Accessibility Site Visit (Master)

Project Name	Sample Property
Visit Type	1
Date of Inspection	01-15-2020
Inspector	Brian Jones
Site Visit Accompaniment	Kevin House/ Julio Perez
Next Action Required:	Physical Site Visit
City	Aiken
State	South Carolina
Number of Buildings	23
Total Number of Units	47
Number of HC Accessible Units	3
Number of A/V Units	1
General Project Notes:	NOTE – Element Findings at Time of Inspection: This inspection report indicates individual elements as Yes, No, or N/A. Each element listed as Yes is compliant and requires no action. Each element listed as No is not compliant and requires action. Each element listed as N/A is non-applicable and requires no action or not installed at the time of inspection.

Community Kitchen

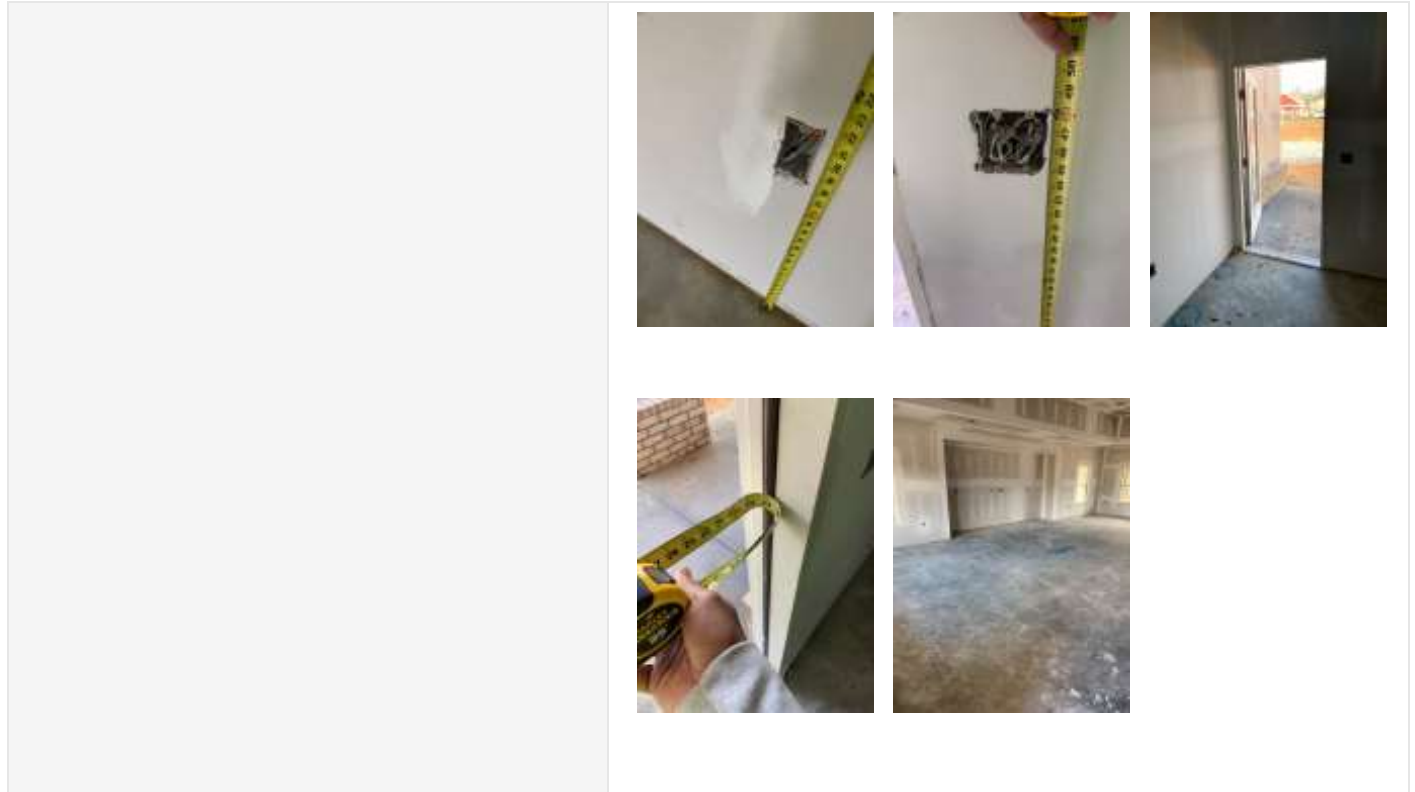
Status of this area	Drywall stage
Doorway has a clear opening width 32" min. (ADA 404.2.3)	Yes
Common Kitchen Photos

Other Community Area Photos

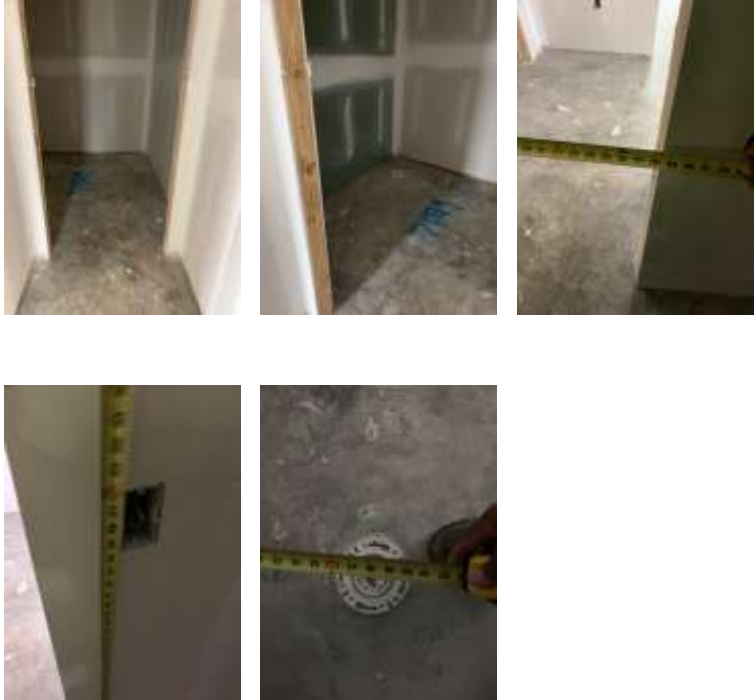
Description of Community Area	Community Building
Doorway has a clear opening width 32" min. (ADA 404.2.3)	Yes
Electric switches 48" max. AFF and outlets 15" min.	Yes

Laundry Area Photos

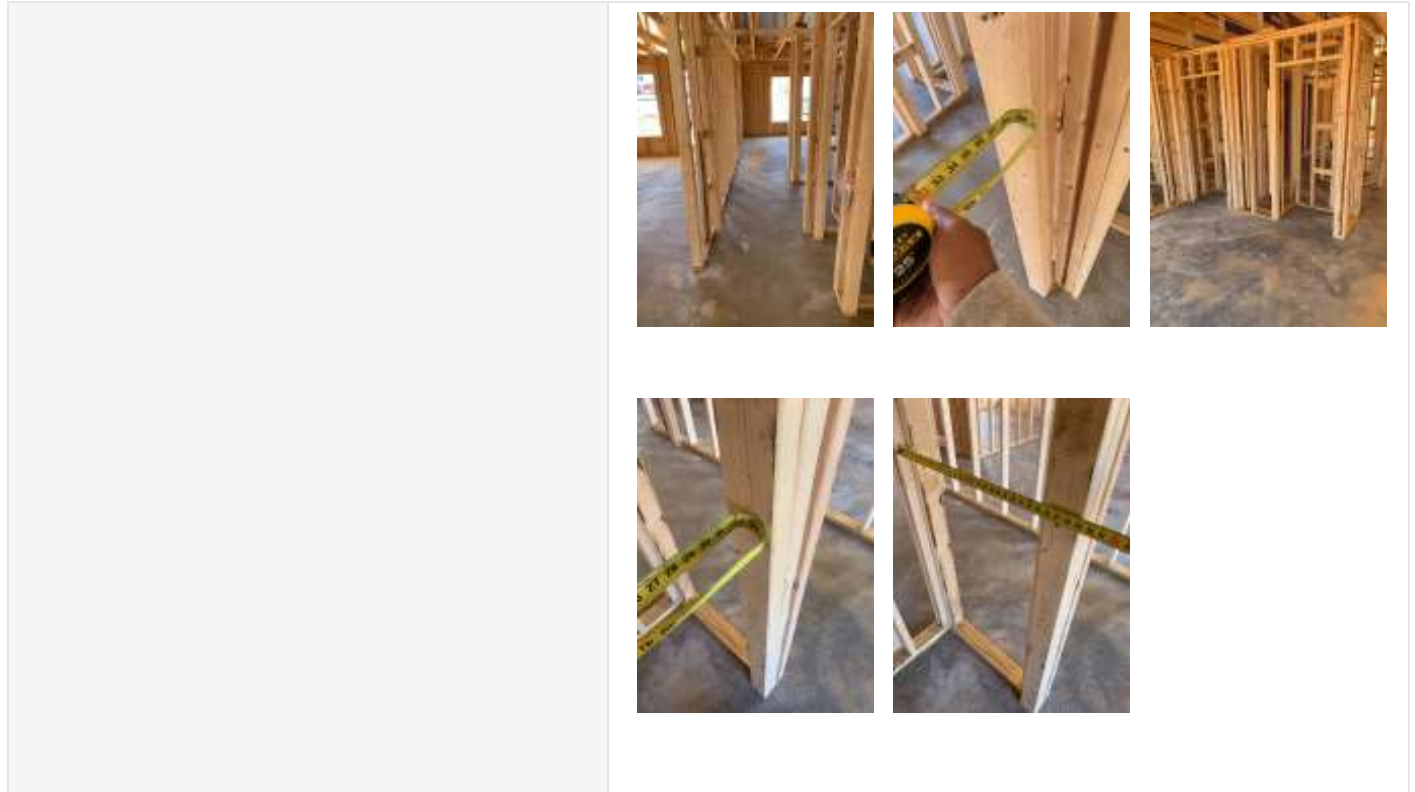
Status of this area	Framing stage
Doorway has a clear opening width 32" min. (UFAS 4.13.5)	Yes
Additional Comments for Laundry Area	No electrical installed at the time of inspection
